Access Compliance Report

Public Rights-of-Way

(Curb Ramps)

Intersection ID: 51370	Main Street: UNIVERSITY_POINTE_BV	Cross Street: IKEA_BV	Location: W
ADA ID: 5B1F766886A5	Ramp Type: Perp	Initial Pass/Fail: Pass	Overall Compliance: No
Severity Score: 0			
Codes/Mitigation Info/Possible Solution		Field Measurements/Component Compliance

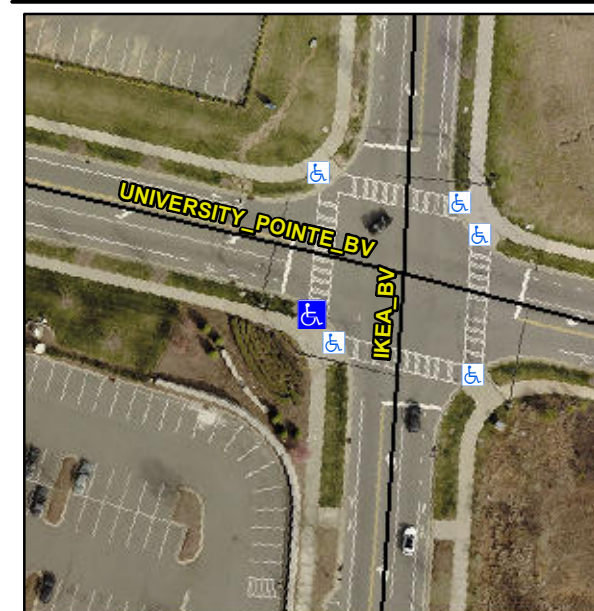
Not Found, R304.2.2-Perp, R304.3.2-Para

Compliance	Description	Data	Compliance	Description	Data
N/A	Ramp Length (in)	101.0	Yes	Ramp Slope (%)	5.2
Yes	Ramp Width (in)	57.0	Yes	Ramp XSlope (%)	1.5
N/A	Flare Type LT	Sloped	N/A	Flare Type RT	N/A
N/A	Flare Slope LT (%)	8.0	N/A	Flare Slope RT (%)	11.8
N/A	Flare Traversable LT?	Yes	N/A	Flare Traversable RT?	No
Yes	Landing Length (in)	101.0	Yes	DWS Provided?	Yes
Yes	Landing Width (in)	57.0	Yes	DWS Contrast?	Yes
No	Landing Slope (%)	3.3	Yes	DWS Length (in)	24.0
Yes	Landing X Slope (%)	1.5	Yes	DWS Full Width?	Yes
N/A	Landing Curb? (Y/N)	No	Yes	DWS Offset (in)	1.8
N/A	Shared Landing?	No			
Yes	Gutter Ponding?	No	Yes	Gutter Slope (%)	2.3
Yes	Gutter Lip Ht (in)	0.0	Yes	Gutter X Slope (%)	1.0
N/A	Painted X Walk1?	Yes	N/A	Painted X Walk2?	N/A
	X Walk 1 Direction	To N		X Walk 2 Direction	N/A
N/A	X Walk 1 Width (in)	112.0	N/A	X Walk 2 Width (in)	N/A
	X Walk 1 Slope (%)	5.0		X Walk 2 Slope (%)	N/A
	X Walk 1 X Slope (%)	4.7		X Walk 2 X Slope (%)	N/A

Remove & Replace Entire Ramp.
